ATTACHMENT 1

Con Edison requests a change in Pages 2.3-3 and 2.3-6 of the Indian Point Unit No. 2 Technical Specifications. This revision would change the setpoint for the underfrequency trip of the Reactor Coolant Pumps so that this setpoint is more consistent with the known stability of the power grid and the maximum anticipated frequency decay rate.

### Indian Point Unit No. 2 Underfrequency Study

Figure 1 Unit 2 Indian Point

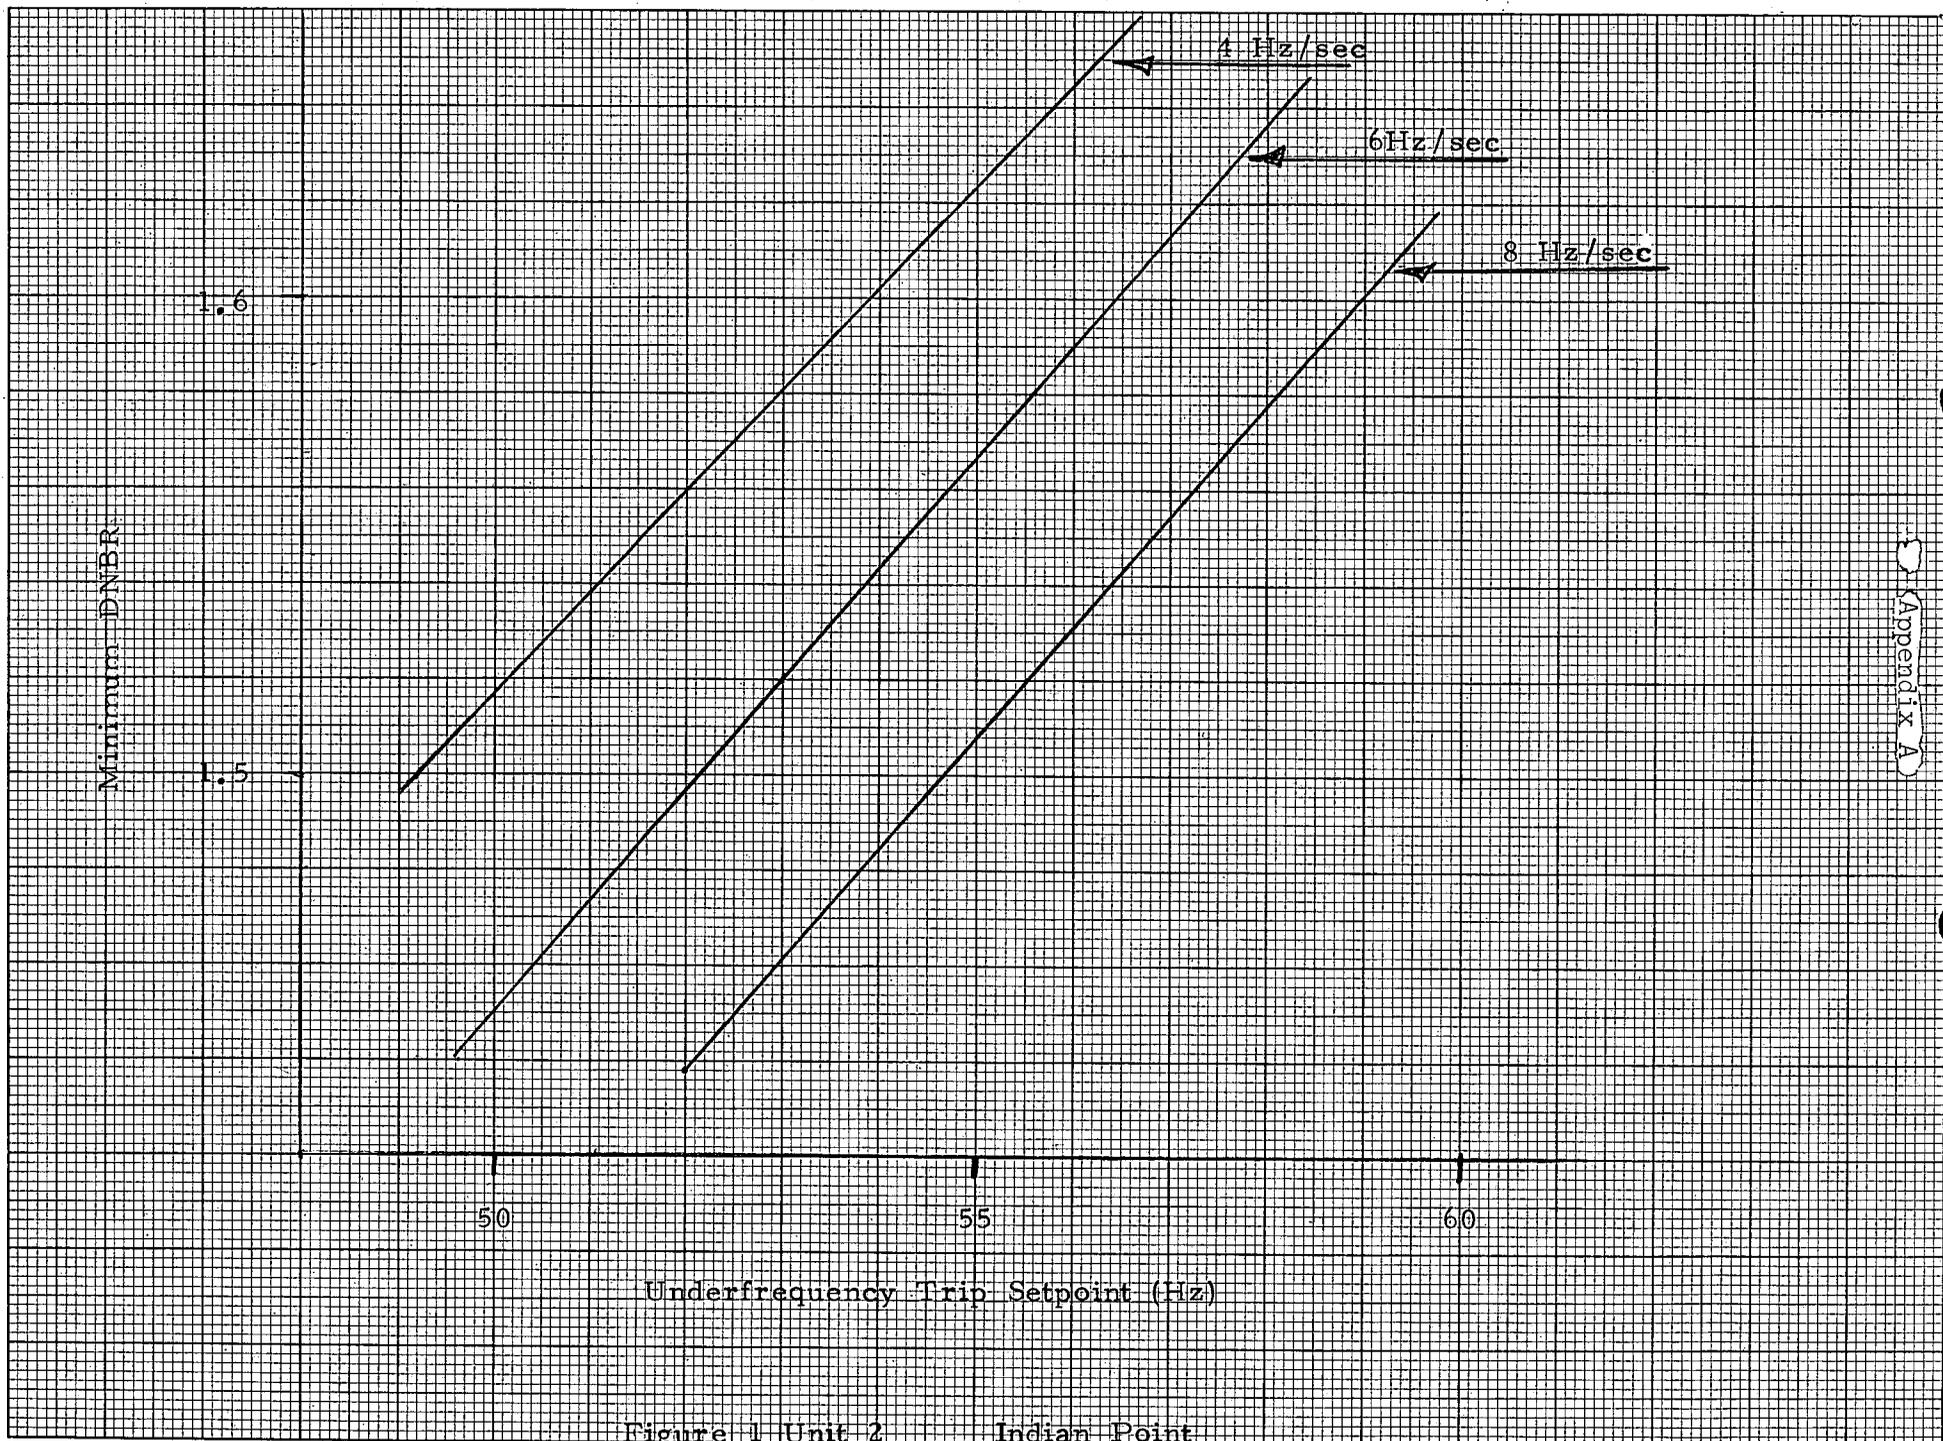
Figure 1 is a plot of minimum DNBR versus underfrequency trip setpoints at various frequency decay rates for Unit No. 2. Graphs of key system variables are shown in Figures 2a, 2b, 2c and 2d, which are, respectively, core flow, nuclear power, hot channel heat flux, and DNB ratio versus time for a 4 Hz/sec frequency

A 55 Hz trip with a 6 Hz sensor time delay will provide core protection (e.g., minimum core DNBR 1.30) for frequency rates of up to 12 Hz/sec for Indian Point Unit No. 2.

Figure 3 Unit 2 Indian Point

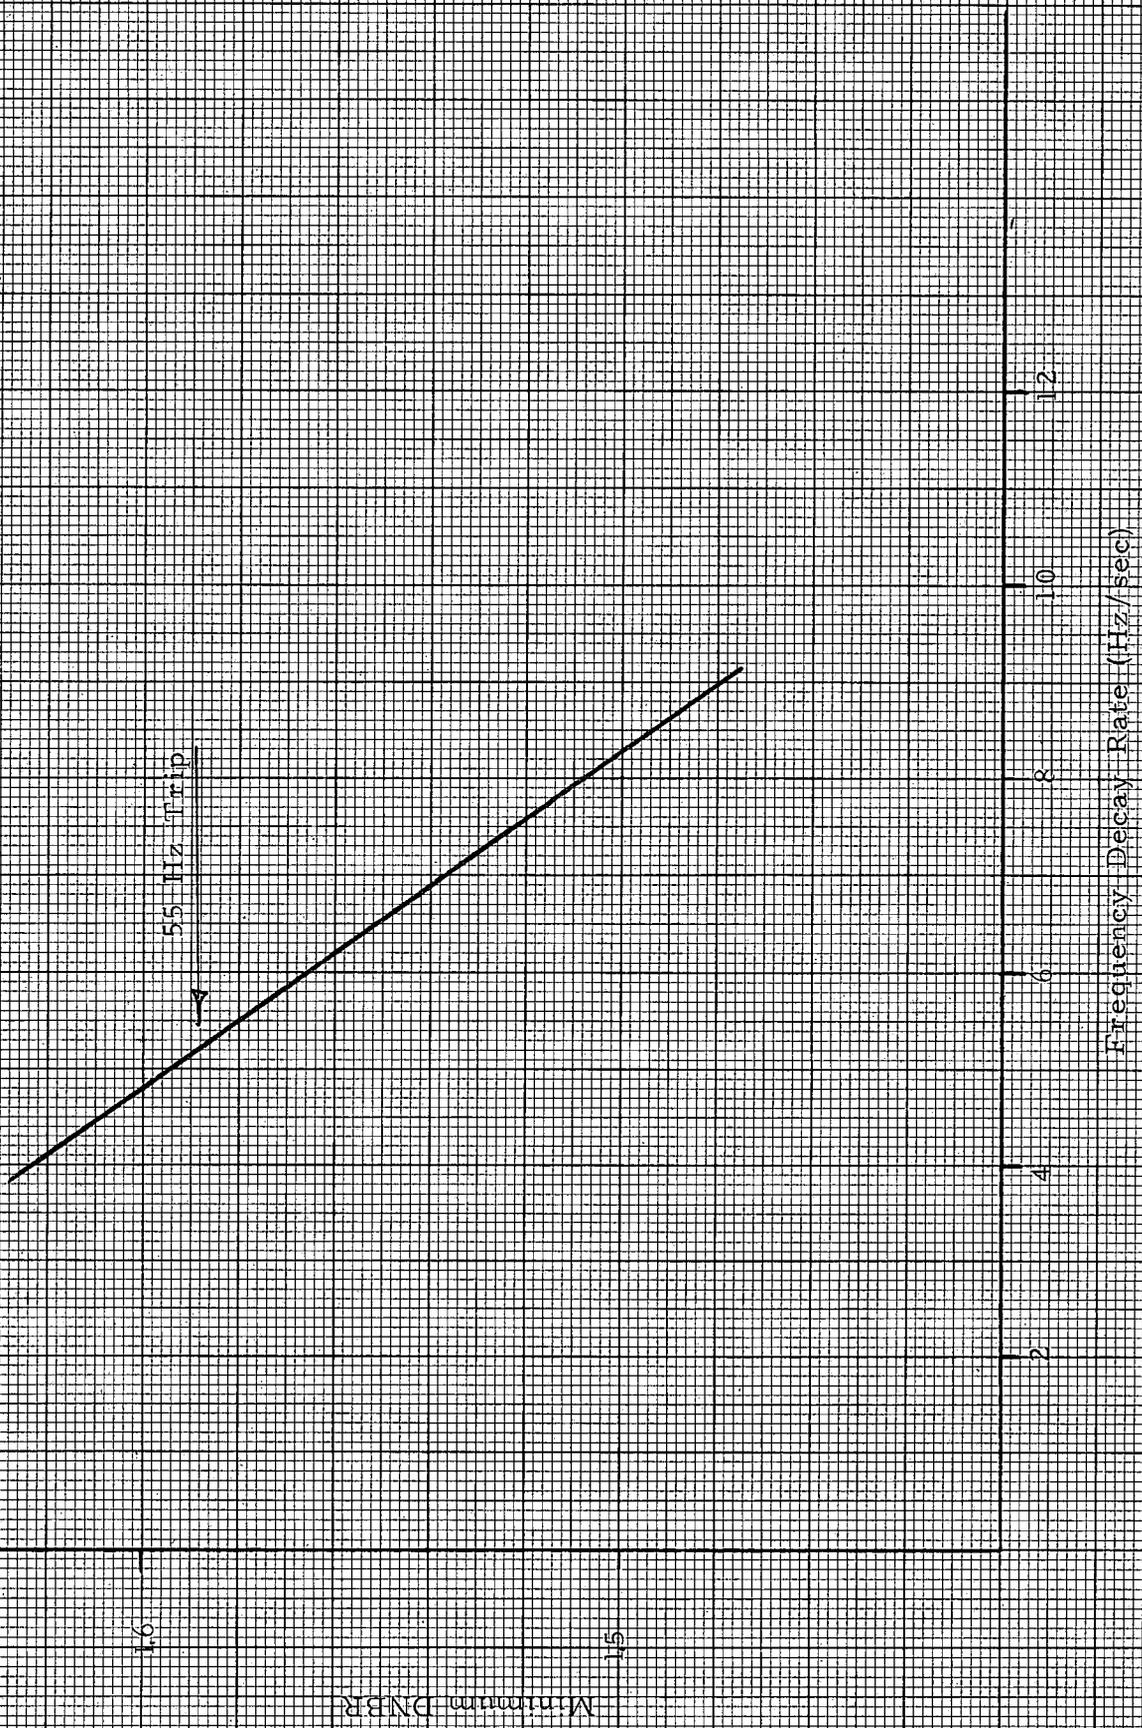
accident assuming a 55 Hz trip setpoint. Figure 3 is a plot of minimum DNBR versus frequency decay rate for Unit No. 2 with a 55 Hz trip setpoint.
